SUBJECT: AMENDMENT NOS. 257 AND 217 TO FACILITY OPERATING LICENSES NOS.  
DPR-52, AND DPR-68: PRESSURE AND TEMPERATURE LIMITS - TECHNICAL  
SPECIFICATION CHANGE TS-393 (TAC NOS. MA1304 AND MA1305)

BROWNS FERRY NUCLEAR PLANT, UNIT 2

BROWNS FERRY NUCLEAR PLANT, UNIT 3

SAFETY EVALUATION BY THE OFFICE OF NUCLEAR REACTOR REGULATION  
RELATED TO AMENDMENT NO. 257 TO FACILITY OPERATING LICENSE NO. DPR-52,  
AND AMENDMENT NO. 217 TO FACILITY OPERATING LICENSE NO. DPR-68  
TENNESSEE VALLEY AUTHORITY  
BROWNS FERRY NUCLEAR PLANT UNITS 2, AND 3  
DOCKET NOS. 50-260 AND 50-296

Figure 3.4.9-1  
Pressure/Temperature Limits

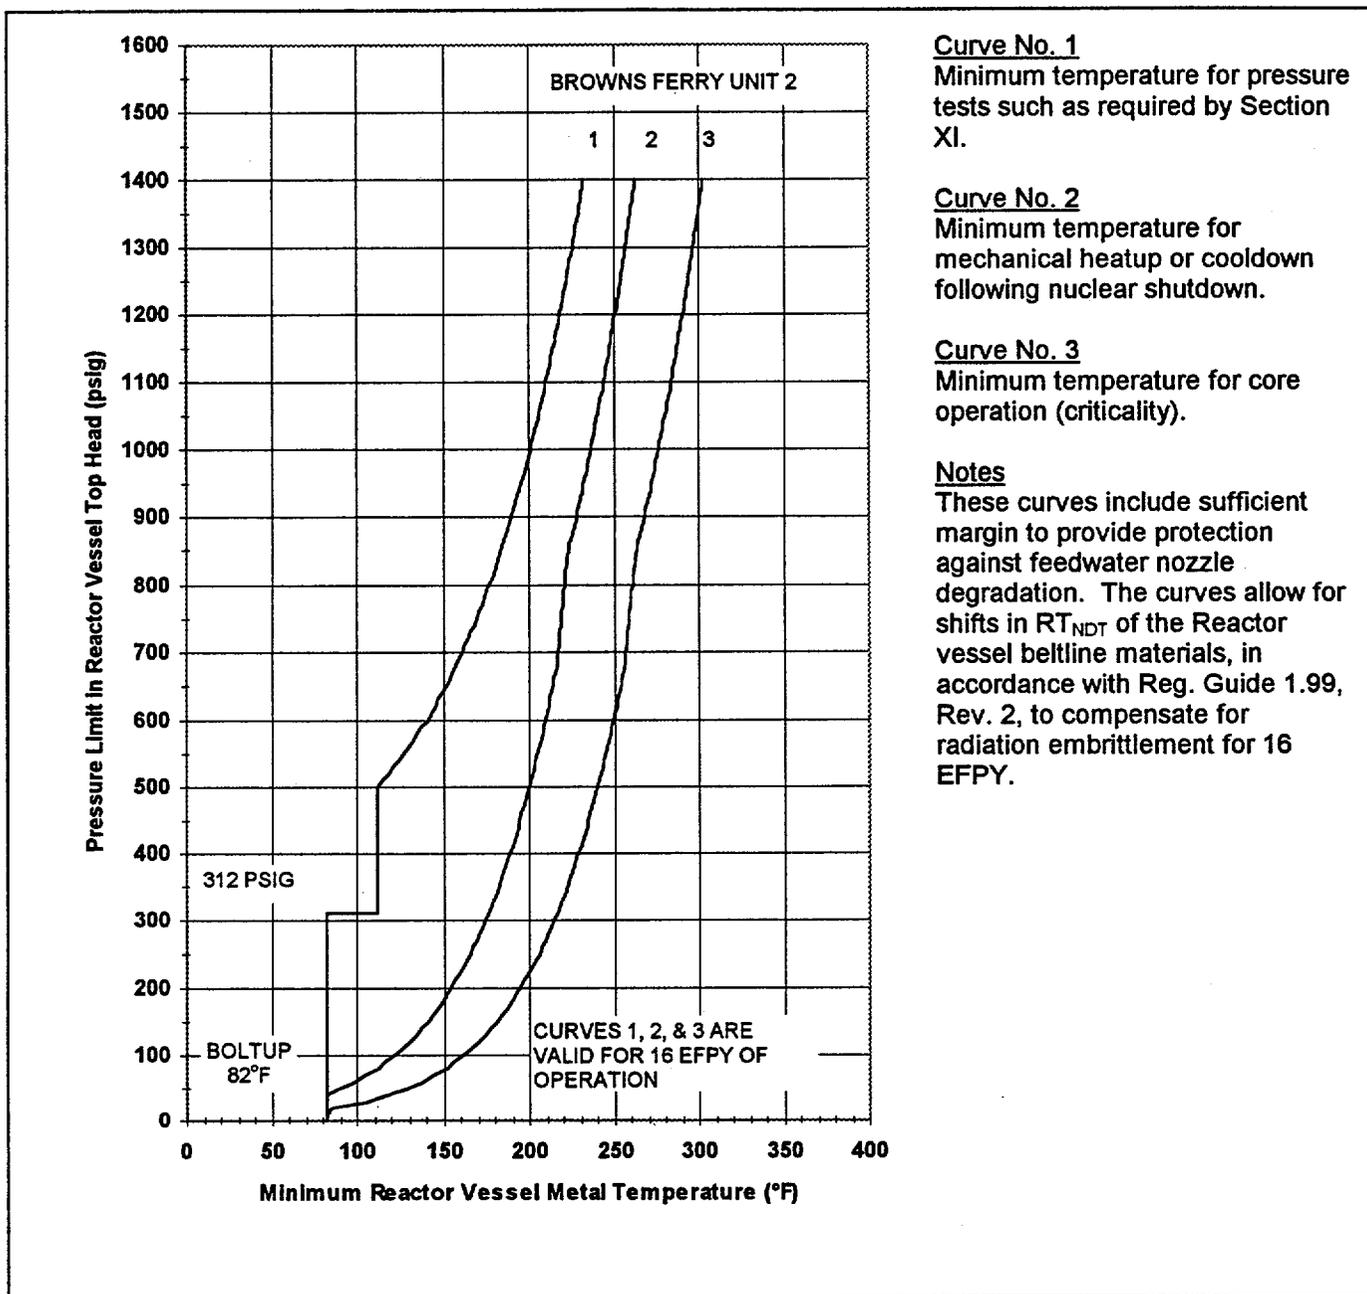
**Notes**  
These curves include sufficient margin to provide protection against feedwater nozzle degradation. The curves allow for shifts in  $RT_{NDT}$  of the Reactor vessel bellline materials, in accordance with Reg. Guide 1.99, Rev. 2, to compensate for radiation embrittlement for 16 EFPY.

Revise the Appendix A Technical Specifications by removing the pages identified below and inserting the enclosed pages. The revised pages are identified by the captioned amendment number and contain marginal lines indicating the area of change.

Figure 3.4.9-1  
Pressure/Temperature Limits

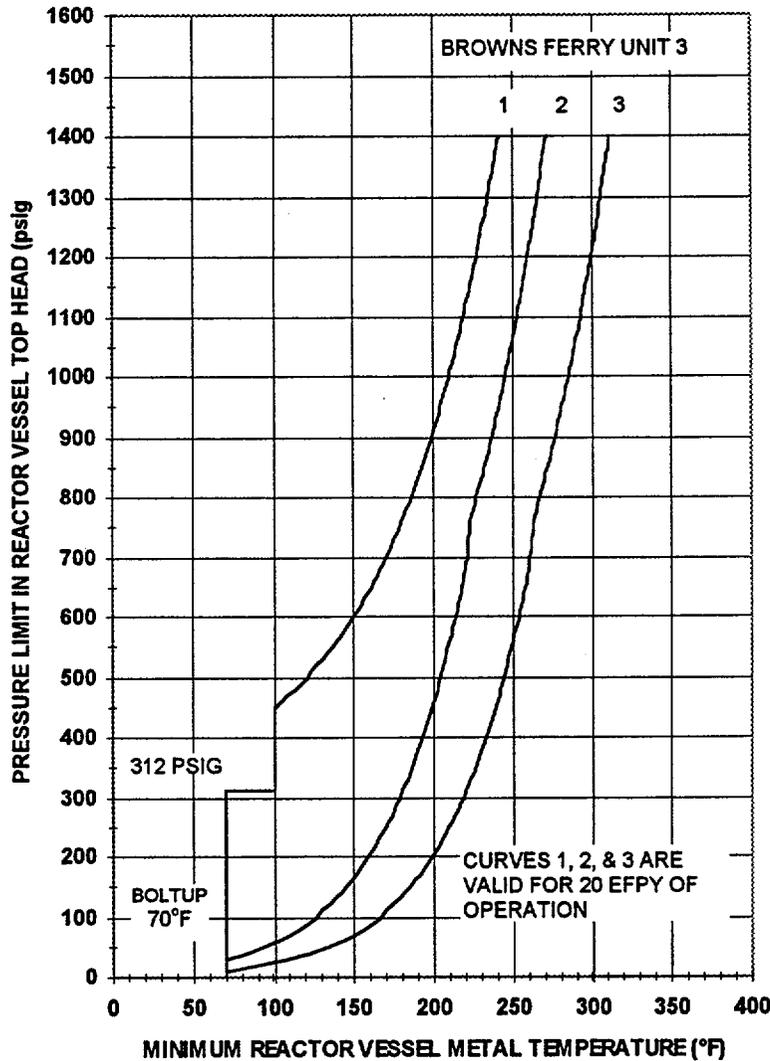
These curves include sufficient margin to provide protection against feedwater nozzle degradation. The curves allow for shifts in  $RT_{NDT}$  of the Reactor vessel beltline materials, in accordance with Reg. Guide 1.99, Rev. 2, to compensate for radiation embrittlement for 20 EFPY.

Revise the Appendix A Technical Specifications by removing the pages identified below and inserting the enclosed pages. The revised pages are identified by the captioned amendment number and contain marginal lines indicating the area of change.
